Appendix I
for MPC Paper No. A/K13/316A

**Proposed Redevelopment of an Existing Industrial Building
With Minor Relaxation of Plot Ratio and Building Height Restrictions
at No. 33 Tai Yip Street, Kwun Tong
- S16 Planning Application -**

**Proposed Redevelopment of an Existing Industrial Building
With Minor Relaxation of Plot Ratio and Building Height Restrictions
at No. 33 Tai Yip Street, Kwun Tong
- S16 Planning Application -
TPB Ref.: A/K13/316
Further Information No. 1**

RESPONSE-TO-COMMENT TABLE

PROJECT		REDEVELOPMENT AT 33 TAI YIP STREET - N.K.I.L. 5595			DRAWING TITLE			
					TYPICAL FLOOR LAYOUT PLAN (TYPE A)			
ARCHITECT	<div>arch design architects ltd. 雅 緻 建 築 設 計 ARCH DESIGN ARCHITECTS LTD.</div>	DWG.NO.	DATE	SCALE	SIZE			
		008	11.05.2020	1:200	A3

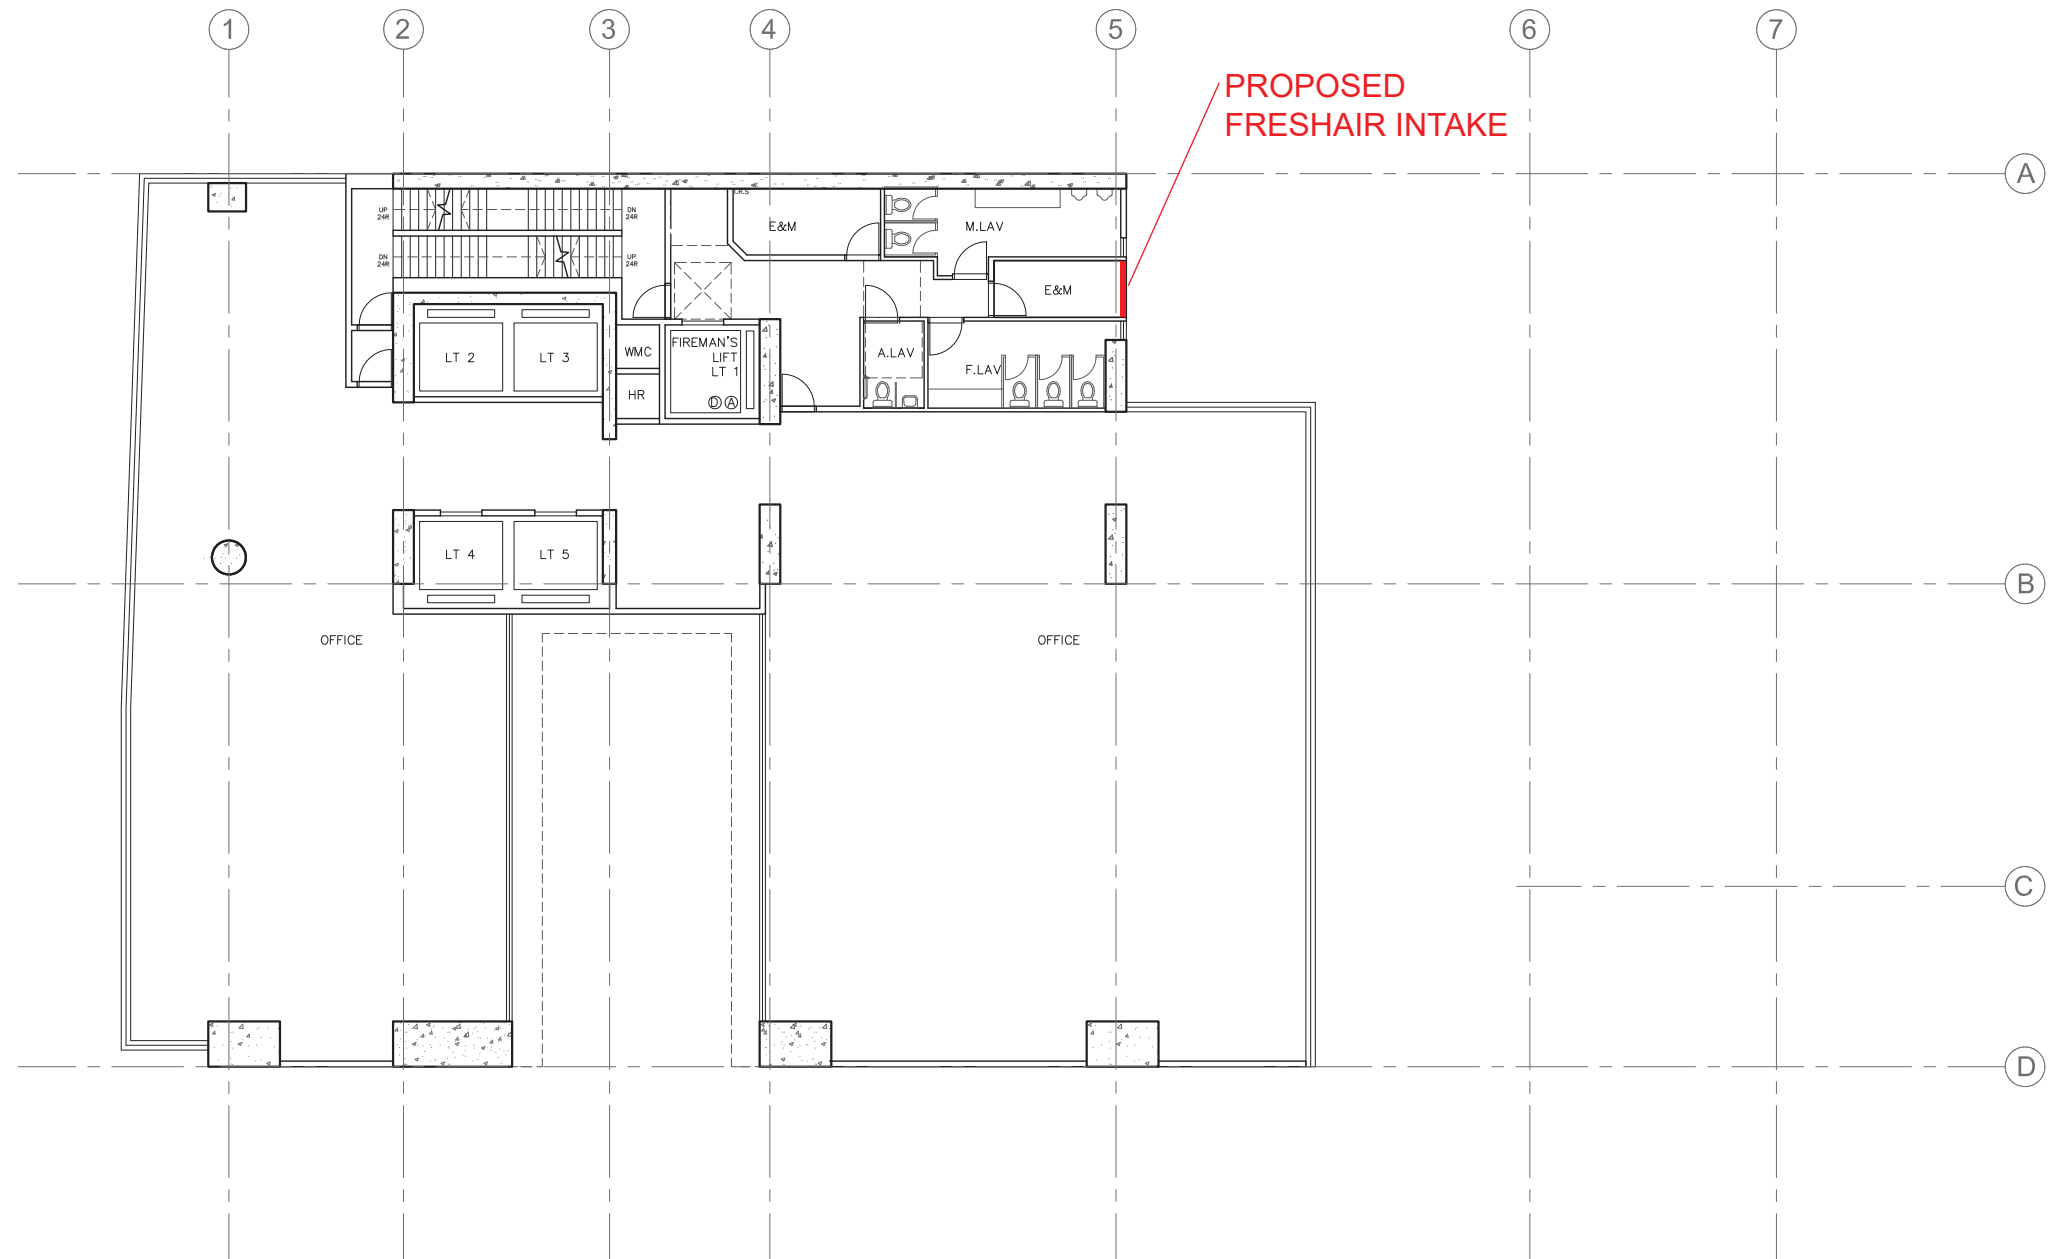
Please find attached 70 copies of the Typical Floor Layout Plan which also indicates the location of fresh air intake.

DRAWING TITLE
TYPICAL FLOOR LAYOUT PLAN (TYPE A)

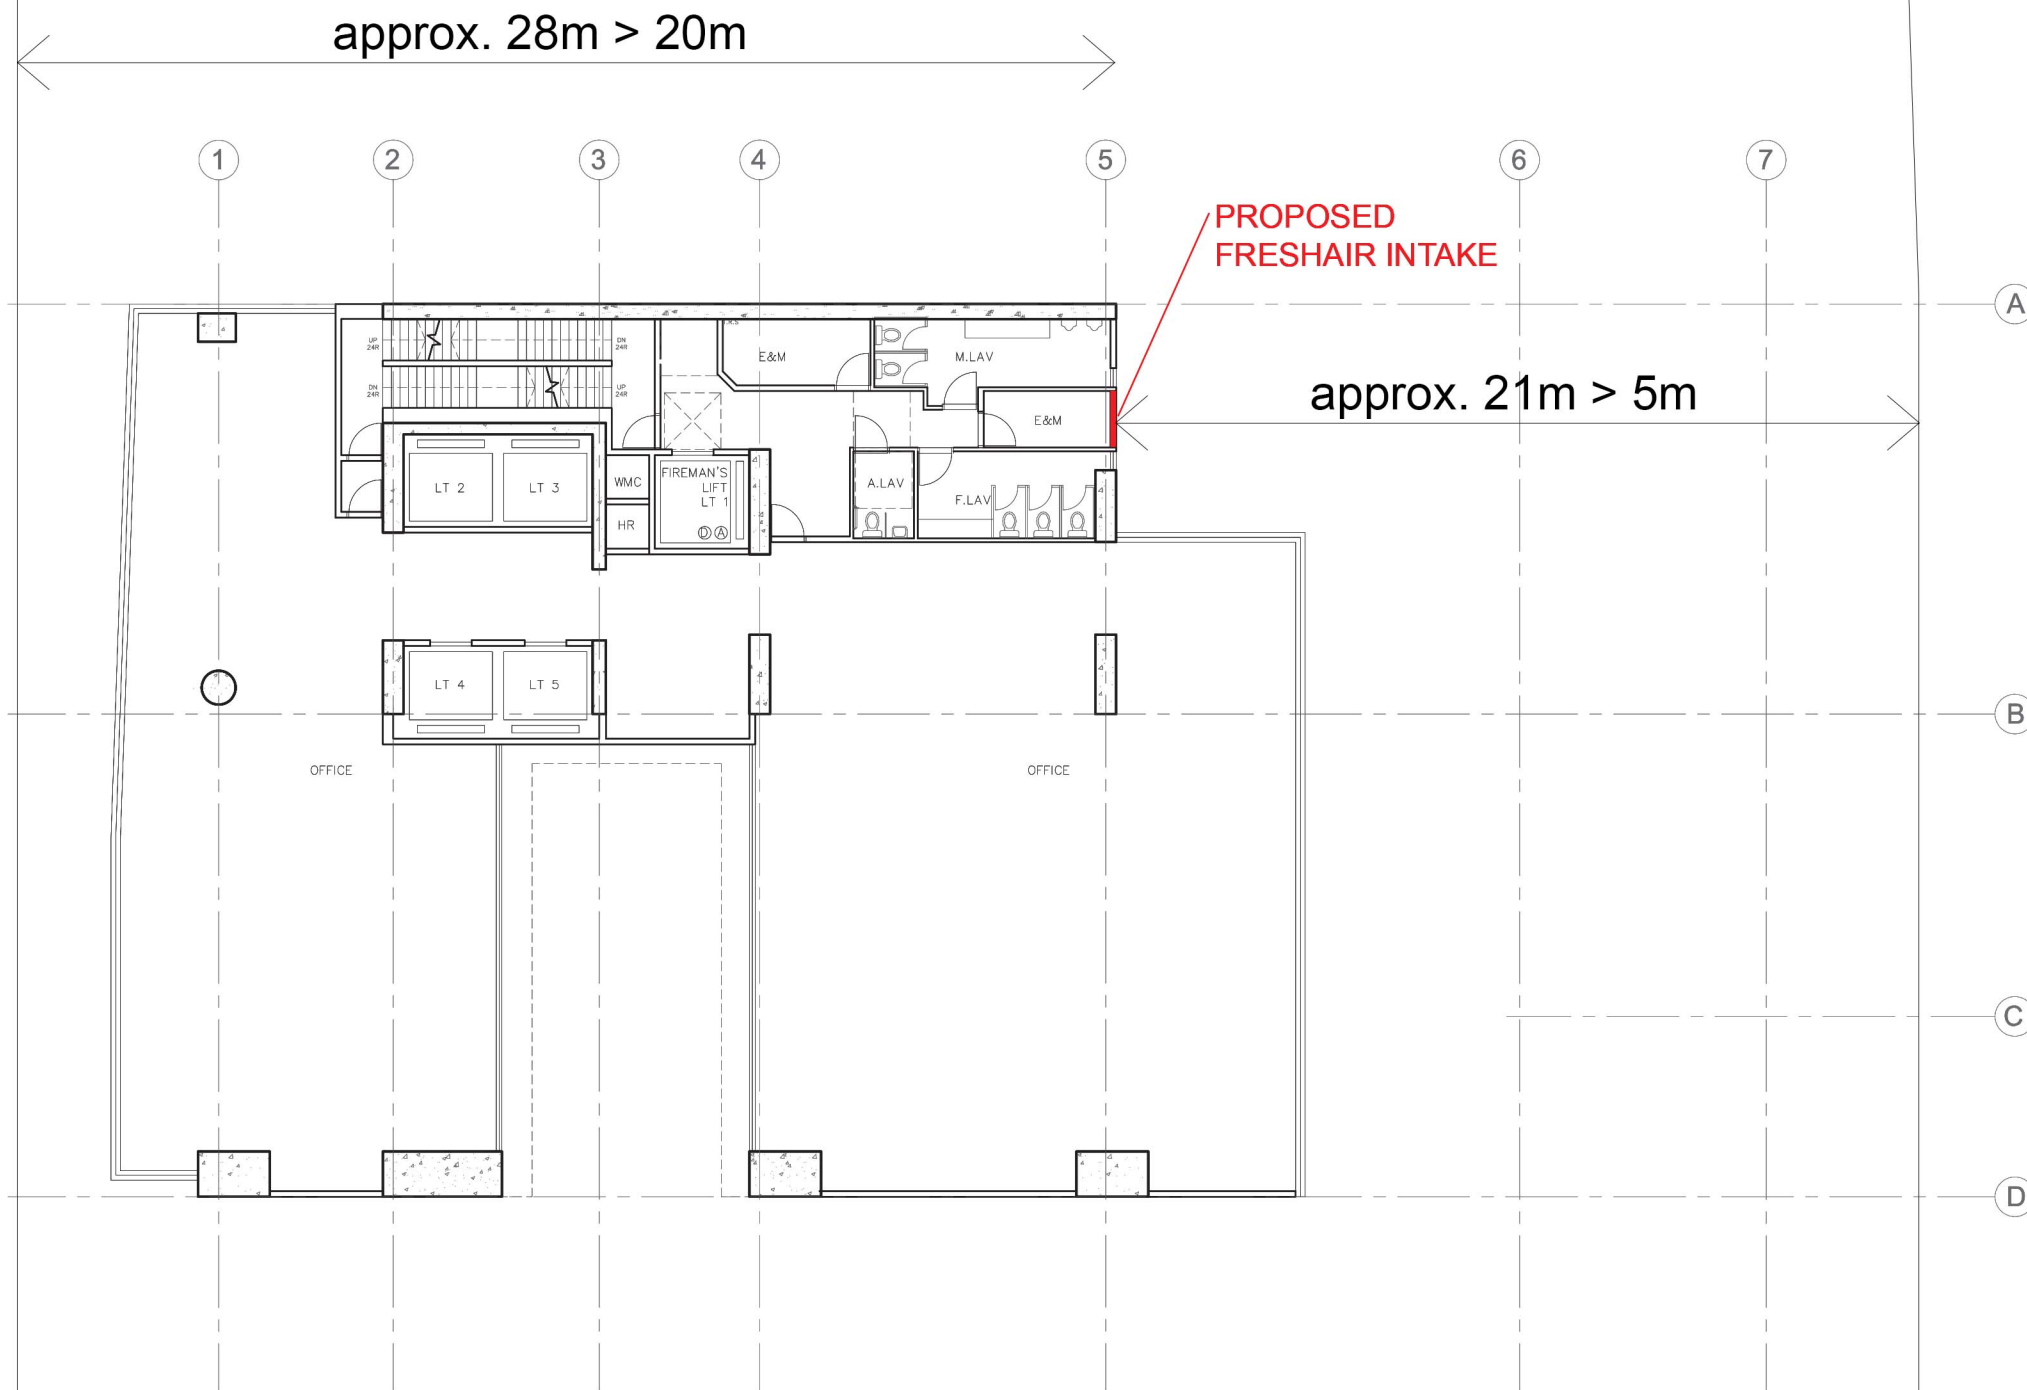
Comments	Response
<p>Email dated 15 June 2020 refers:</p> <p><u>Comments from Chief Engineer/Mainland South, DSD</u> (Contact person: Mr Anthony S N LO, Tel: 2300 1585)</p> <p>(iii) Appendices B & C – Please review if ‘Total Base Flow to FMH403138’ in the first column of the table should read ‘Total Base Flow to FMH4043138’</p> <p>(iv) Appendices D to G – Please note that the existing 400 mm diameter sewers should be vitrified clay pipes according to our drainage records. Please review the assume roughness value.</p>	<p>Noted. This minor typographic error has been corrected.</p> <p>Noted. The roughness value, ks, has been reduced to 3.0mm, in accordance with Table 5 of the Sewerage Manual, Part 1. It is noted that this value is lower than the previous assumption and the surcharging will therefore be reduced, but the overall findings of the SIA wil reman unchanged.</p>
<p><u>Comments from Director of Environmental Protection</u> (Contact person: Ms Alice HSU, Tel: 2835 1125)</p> <p>a) We note that the applicant has confirmed that central air-conditioning system will be provided for the proposed development and will not rely on opened window for ventilation.</p> <p>b) However, the Typical Floor Layout Plan could not demonstrate that the fresh air intakes located to meet the buffer distance for vehicular emission. Also, the applicant should confirm whether there is any chimey emission within 200m from the Application Site.</p>	<p>Wai Yip Street and Tai Yip Street are classified as Primary and Local Distributor respectively. The corresponding buffer distance required under Hong Kong Planning Standards and Guidelines are >20m and >5m. As shown in the attached Typical Floor Plan, the location of fresh air intake fulfils the aforementioned requirements.</p>

G/F LAYOUT PLAN

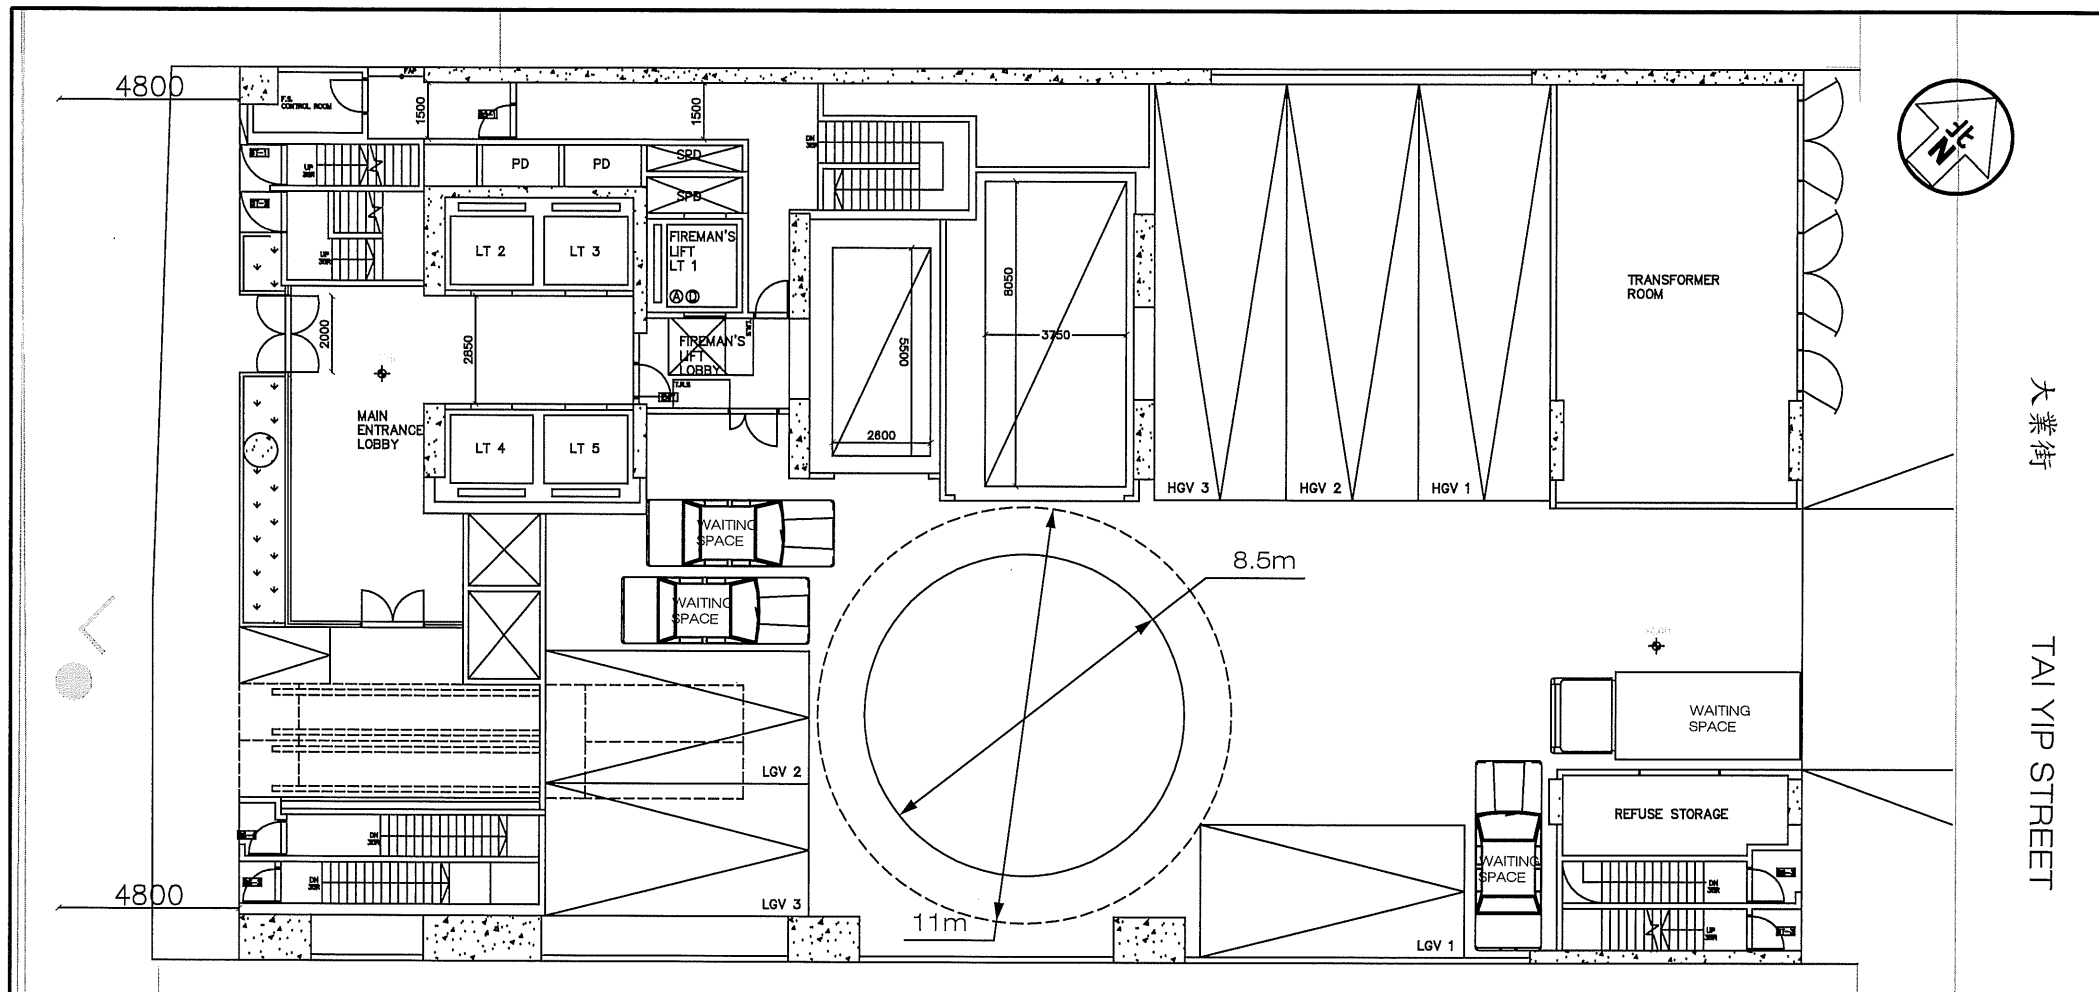
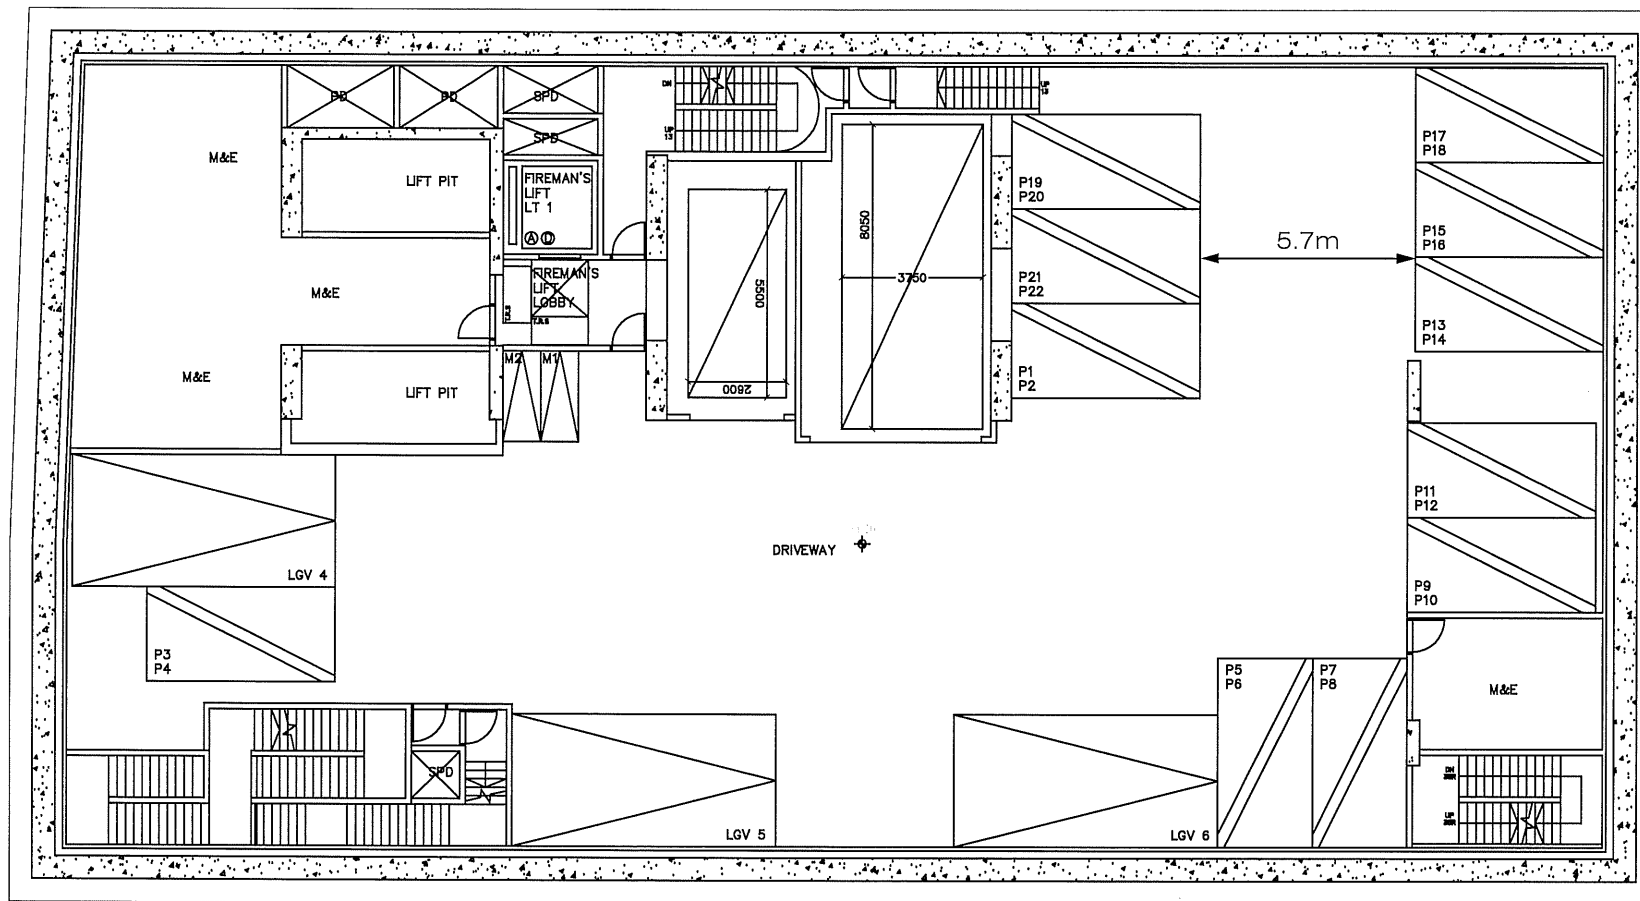
TD requested the Applicant to provide waiting spaces on G/F. As such, we reviewed the G/F and B1-3/F layout and submit herewith a set of revised plans to address their comment. A total of 4 waiting spaces are provided on G/F. We understand that the total number and design of parking facilities and loading/unloading spaces will be subject to approval conditions, thus further submission will be made to the relevant Government departments for consideration at detailed design stage.
